Product Change Notice (PCN)

Subject: Change in Marking Format on Select Humidity Sensor

Affected Product List: HS3001, HS3002, HS3003, HS3004

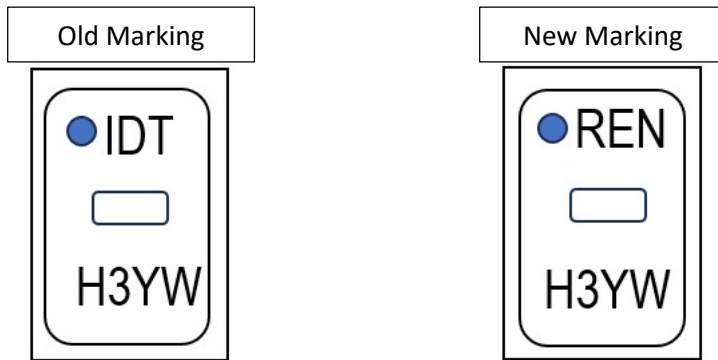
Renesas is changing the marking format by replacing “IDT” with “REN” as shown in the below diagram. No change to form, fit, function, reliability and quality of the product.
